# PRELIMINARY DRAINAGE PLAN PUD/SP 21-00X

### THE RIDGE AT LORSON RANCH

#### Engineering Review

PCD-ENGINEERING REVIEW COMMENTS  
IN BLUE BOXES WITH BLUE TEXT

DATE  
MAY, 2021  
PROJECT NO.  
100.064  
SHEET NUMBER  
1  
TOTAL SHEETS: 5

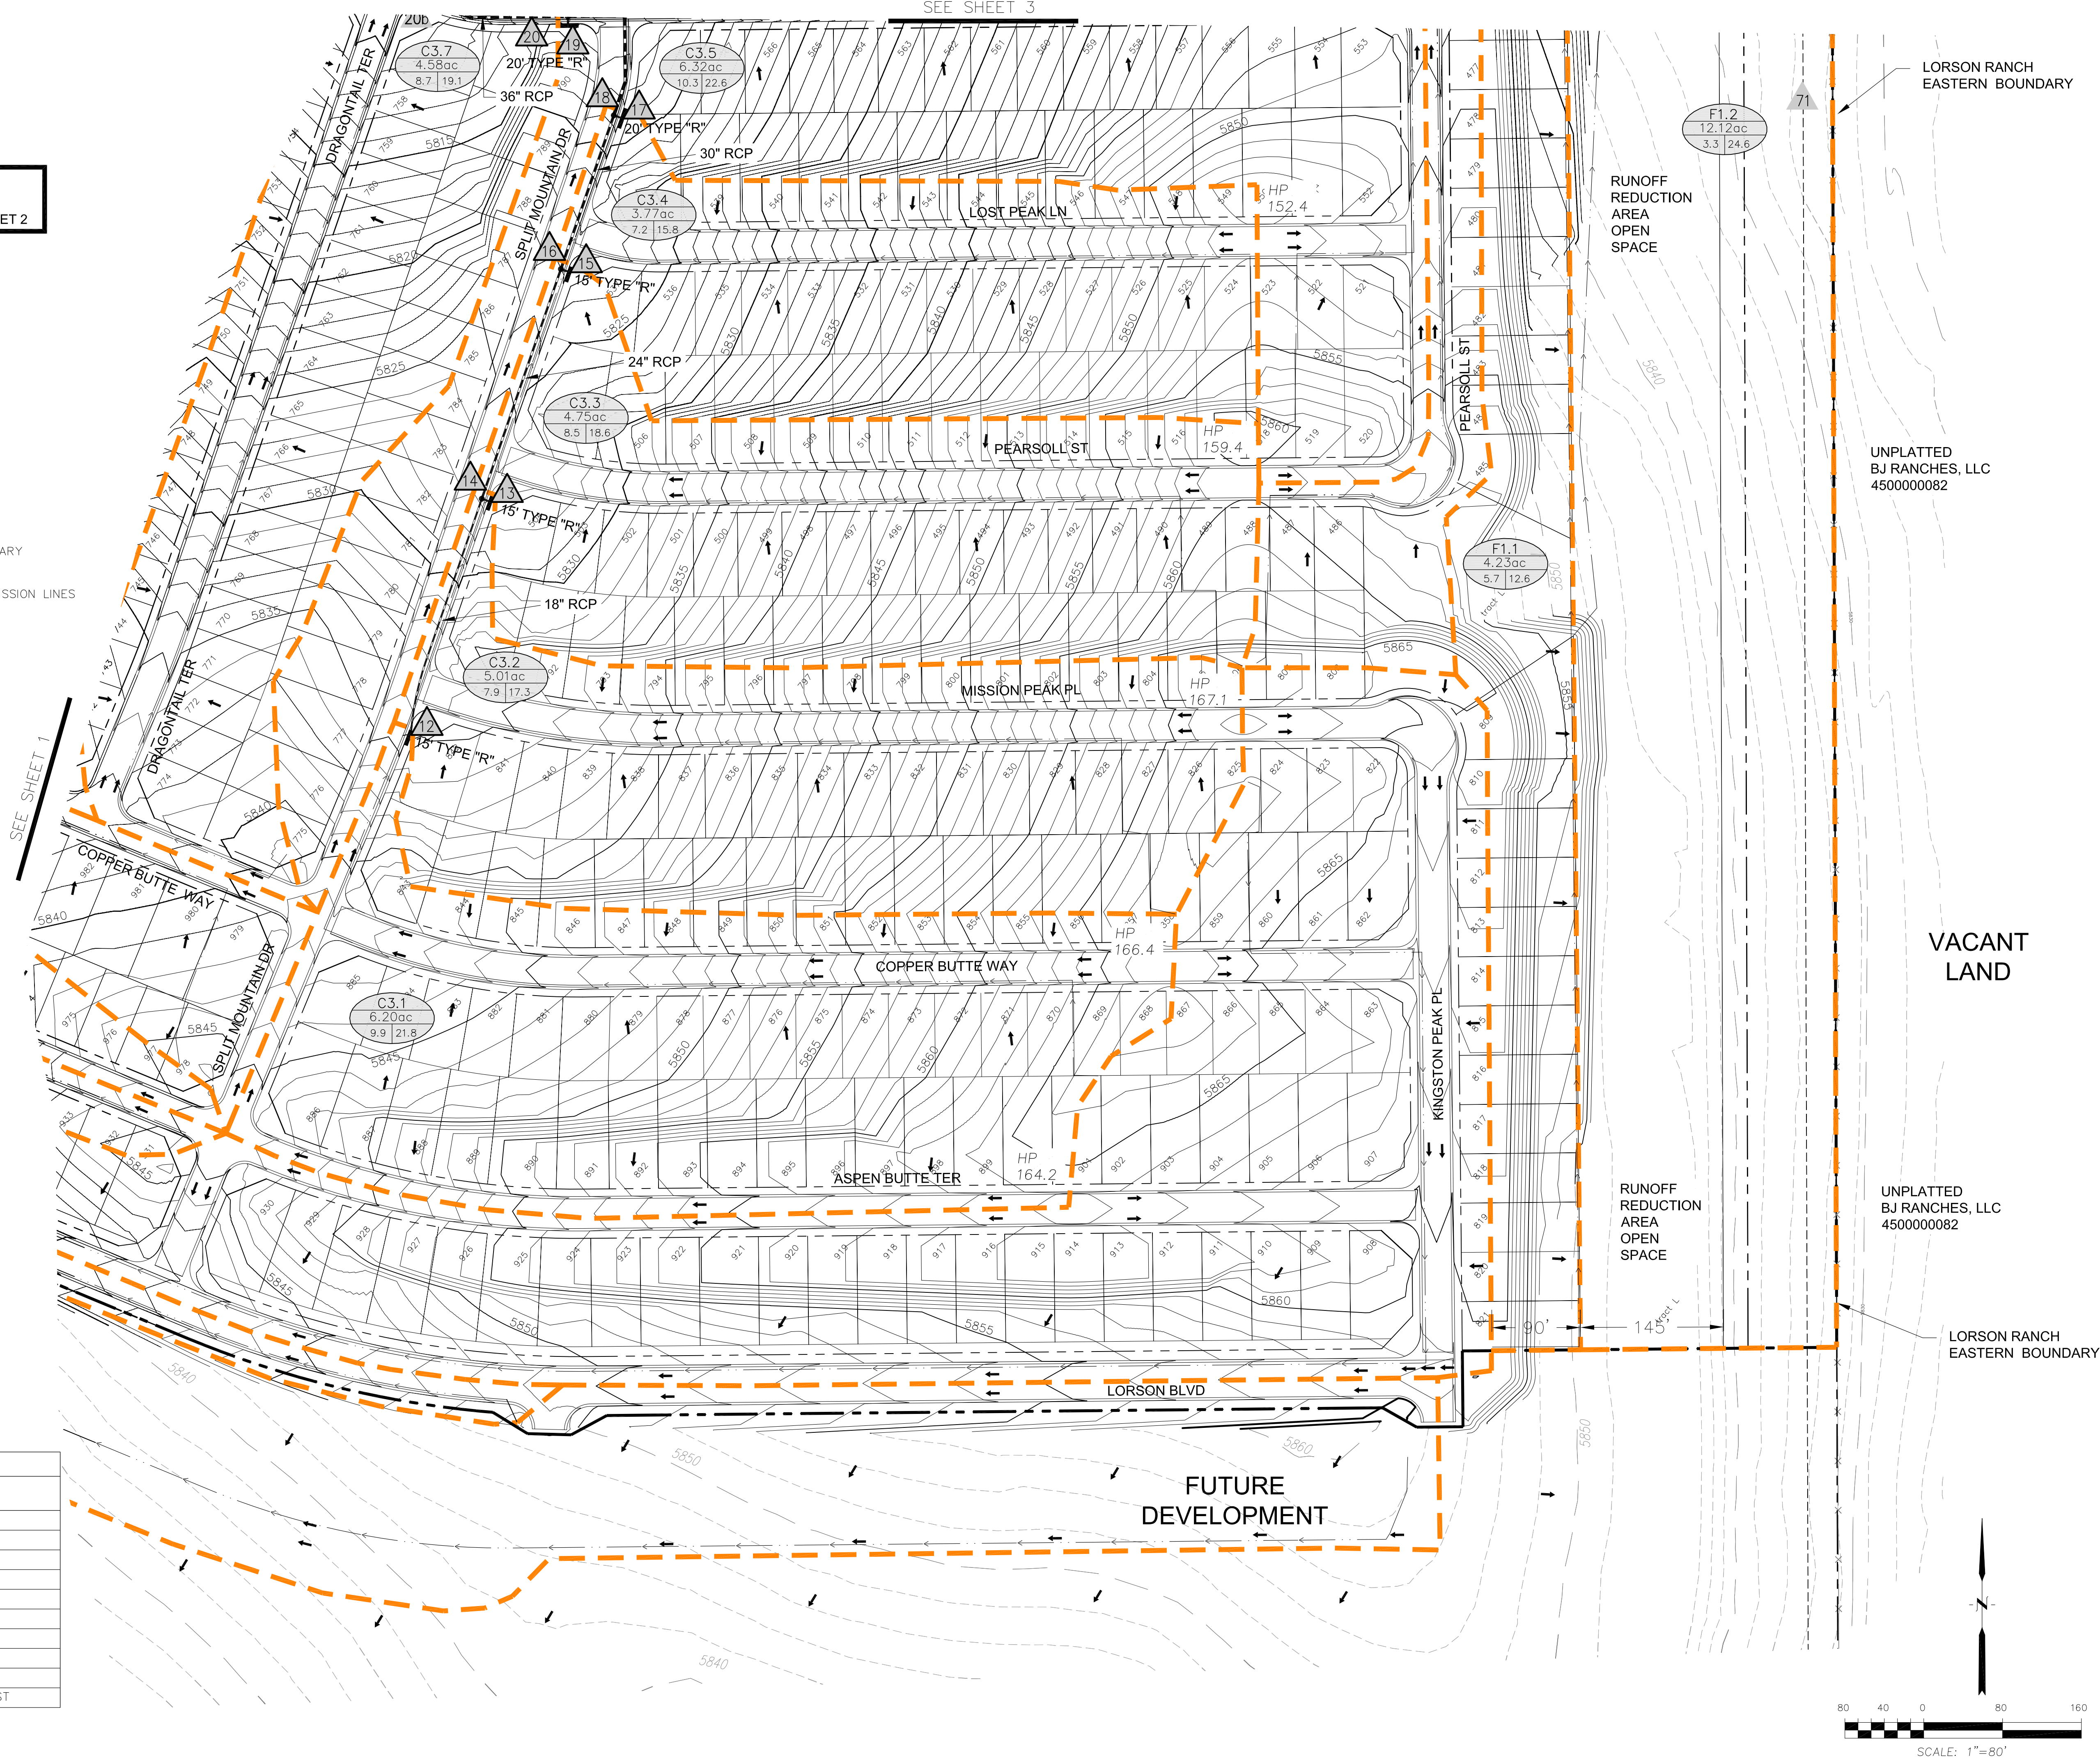
Show and label linetype for areas tributary to each pond as shown on Page 143, typical for all 4 plan sheets.

show existing curb and gutter

DATE: MAY, 2021  
PROJECT NO. 100.064  
SHEET NUMBER 2  
TOTAL SHEETS: 5

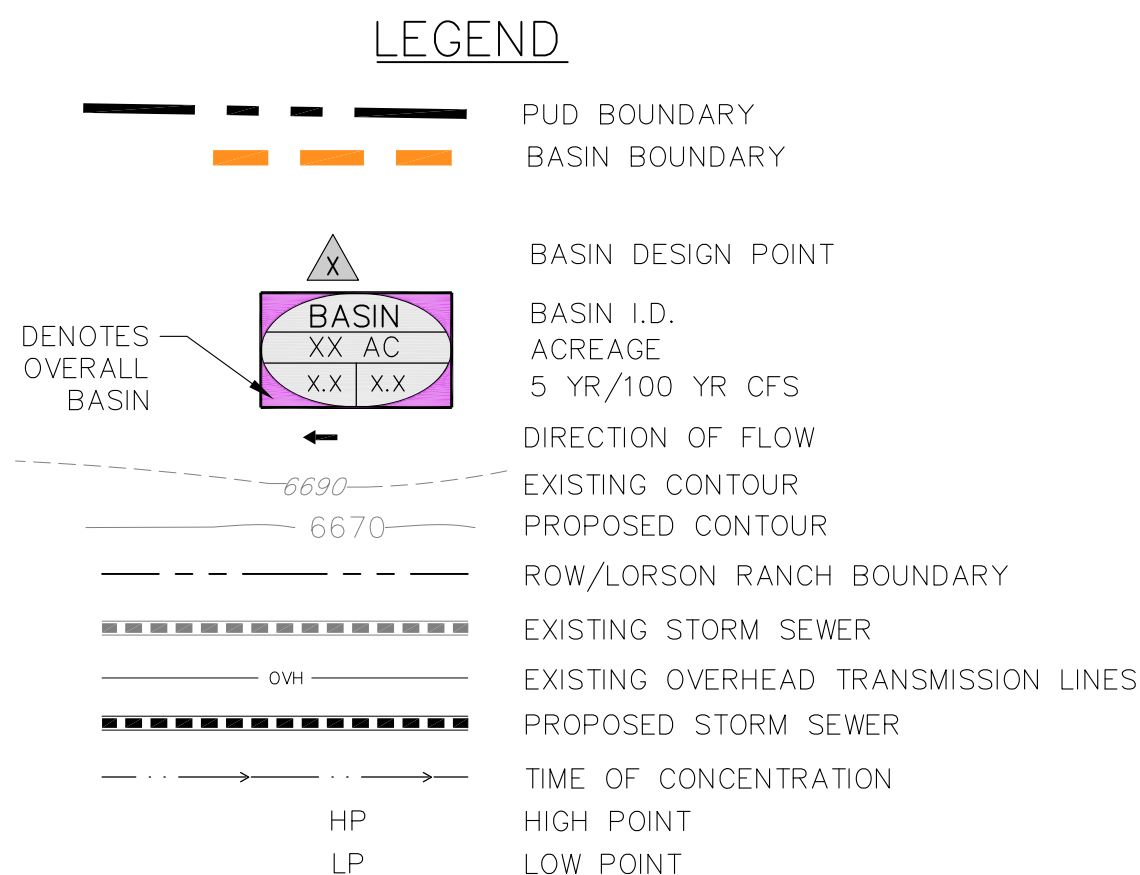
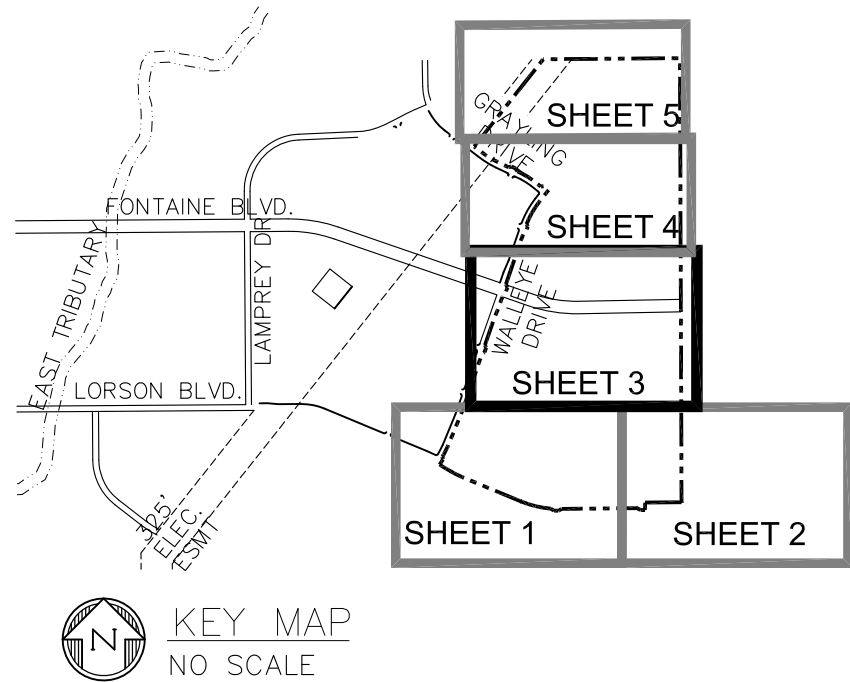
If inlet could overtop with flows >100-yr storm, consider providing a berm or wide swale to ensure that flows don't enter Lot 357.
